**ANACONDA SMELTER NPL SITE
ANACONDA REGIONAL WATER, WASTE & SOILS
OPERABLE UNIT**

***Remedial Design Unit (RDU) 5 Anaconda Active Railroad Beds
Remedial Action Work Plan/Final Design Report (RAWP/FDR)***

**Comments to the Draft Final Remedial Design Unit (RDU) 5
Anaconda Active Railroad Beds Remedial Action Work Plan/Final Design Report
Prepared for Atlantic Richfield Company by Pioneer Technical Services, Inc.
Dated August 15, 2003**

FIGURE 10
2003 ARSENIC SAMPLE RESULTS FOR THE WEST VALLEY RAILROAD BED
 SCALE 1"=100'
 DATE 8/20/03

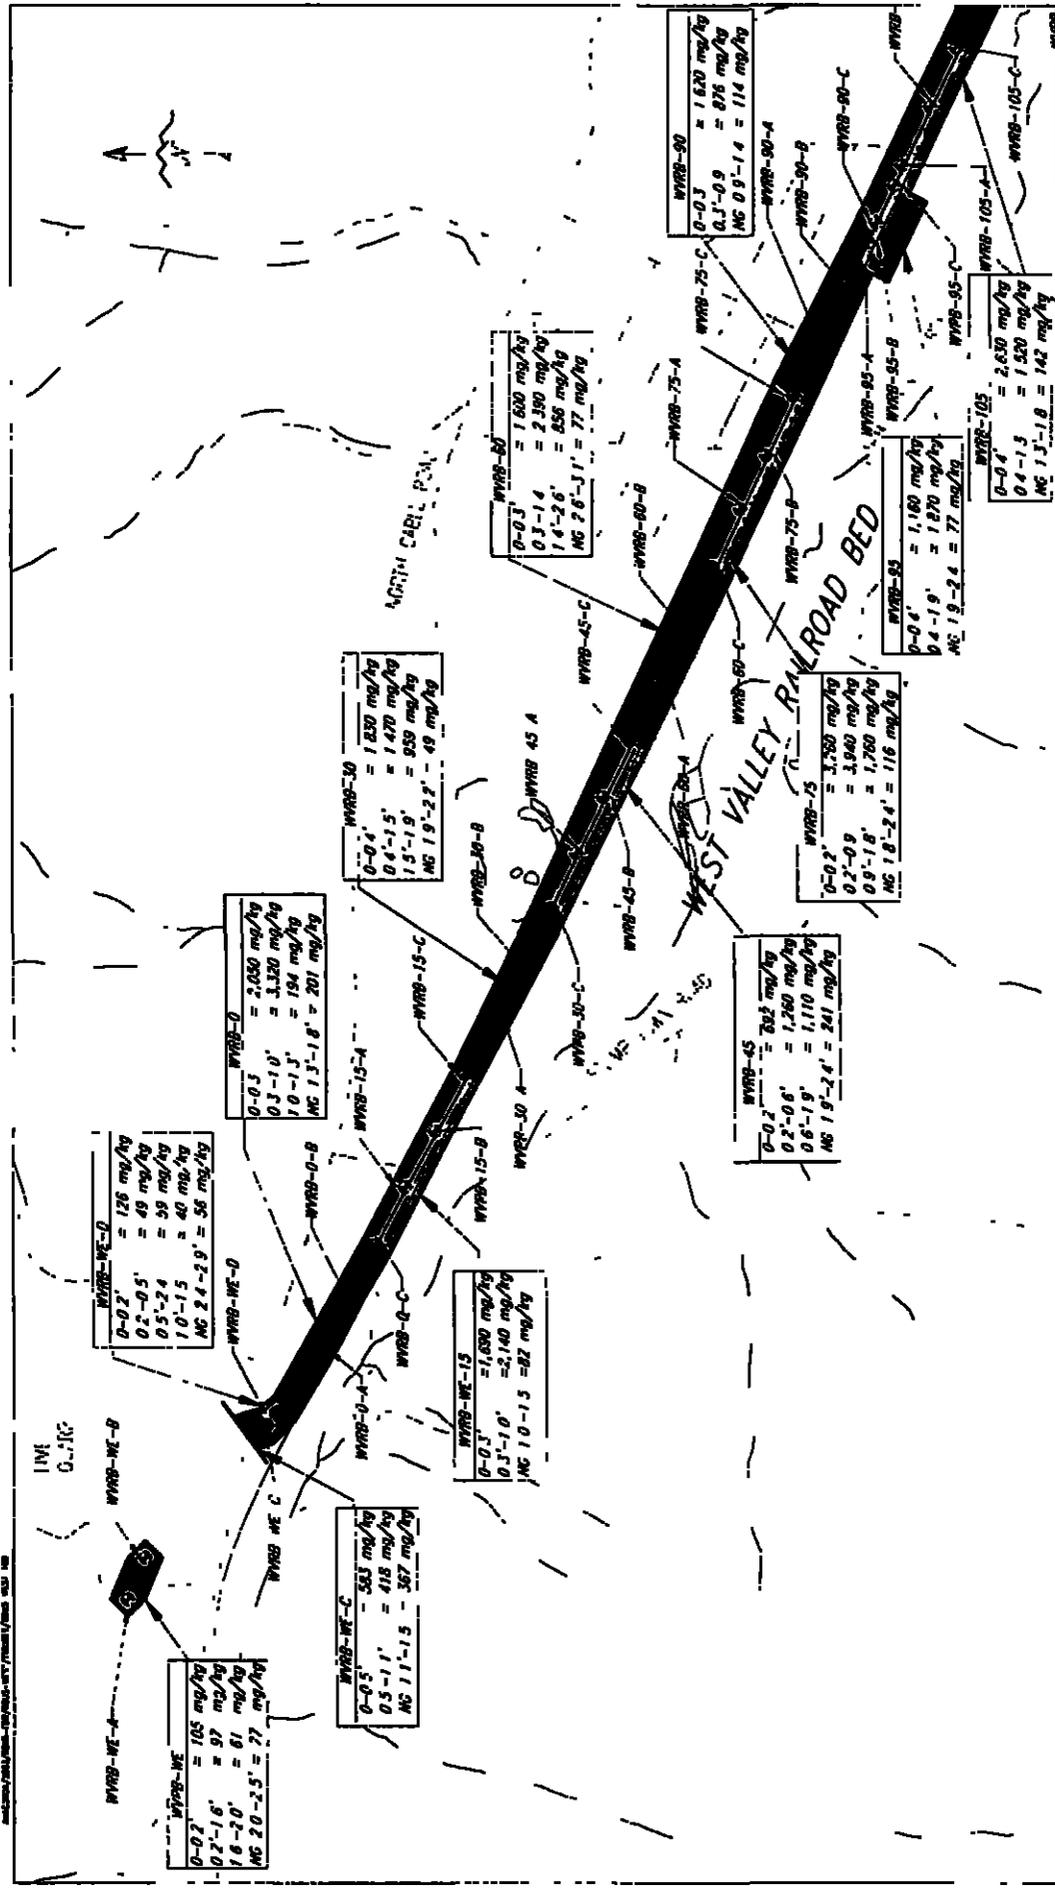
There are about 30 crossings along the rail line, ranging from rotten boards and gravel to asphalt over the ties and rails. Leaving these crossings in place not only makes the removal of waste incomplete, but results in unnecessary maintenance and the potential for safety problems. The stability of a 20 foot wide section of rails and ties sitting 2 feet or so above the ground and subject to traffic is questionable. Also, it is questionable whether leaving rails and ties in place meeting federal and state requirements for railroad abandonment. In addition, it is the Agencies understanding that in order to comply with the agreement reached between MT DOT, Rarus, and ARCo regarding the condition of property prior to transfer, all crossings that may contain waste must be removed. Replacement of these crossings need to be addressed with MT DOT and ADLC.

As discussed during the August 28, 2003 meeting between the Agencies and Atlantic Richfield Company, the design will be revised to include removal of rails, ties and bed material at dirt/gravel railroad bed crossings and replacement with clean aggregate at the crossing where legal easement agreements exist between the landowner and resident/governmental entity. At asphalt crossings, the rails, ties and bed material will be removed up to the edge of the asphalt, the asphalt will be cut outside the end of the ties, the rails and ties will be removed, and the cut area will be backfilled with compacted road base to a height approximately 4-inches below the existing asphalt. The compacted road base will then be covered with 4-inches of new asphalt.

ANACONDA MAINLINE RR BED TYPICAL RA DETAIL (12)
 STA 300+00 TO 315+50

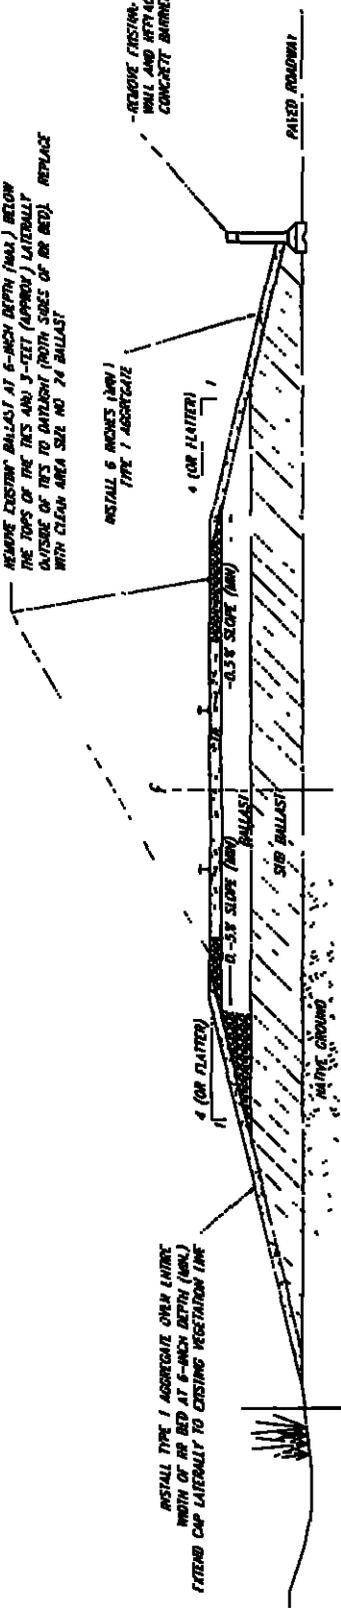
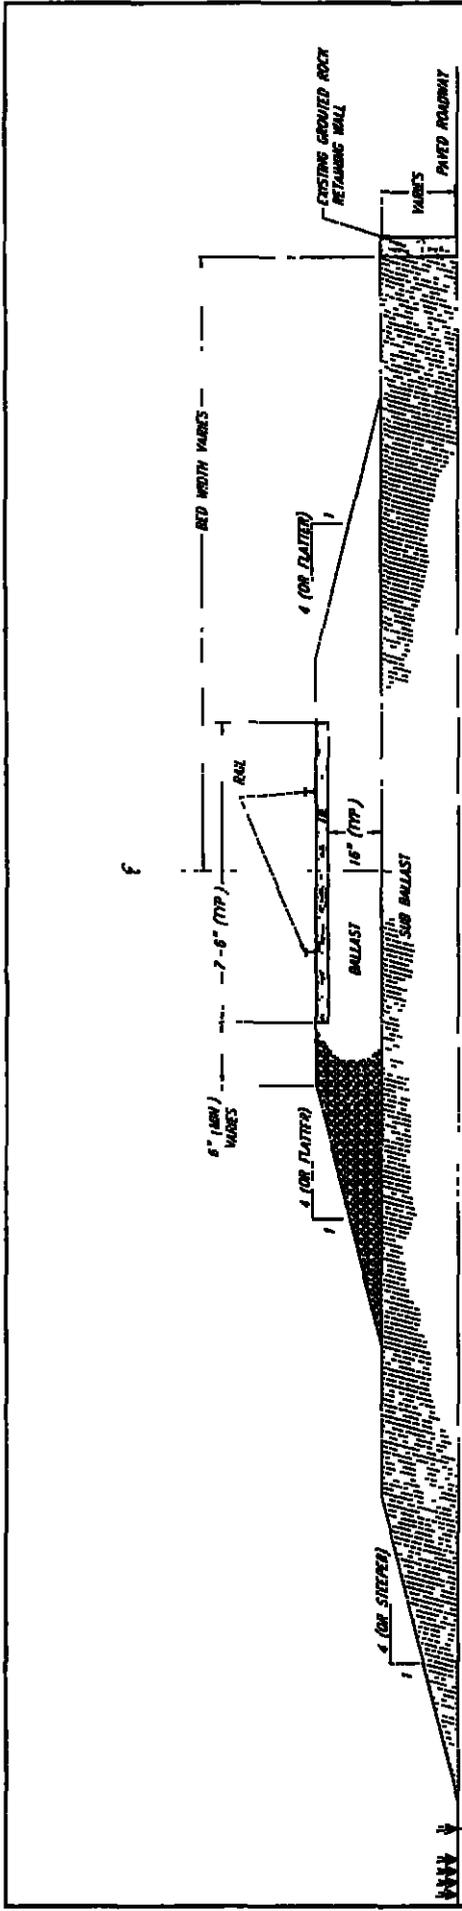
Page 20, Section 5.3 Anaconda Mainline, first complete paragraph, second sentence states. ". a barrier will be installed between the street or alley and the railroad bed. " The use of concrete Jersey barriers adjacent to roadways, alleys and parking areas should be reviewed by ADLC They are not very attractive and are generally not considered for permanent use. Also, the plans call for leaving several existing retaining walls in place. Some of these have deteriorated The stability of the existing walls should be evaluated, and if left in place, the monitoring and maintenance plan must address these specifically

Atlantic Richfield Company has discussed the deteriorated wall along Front Street and will remove the wall and replace it with a barrier to prevent vehicular access adjacent to Front Street.
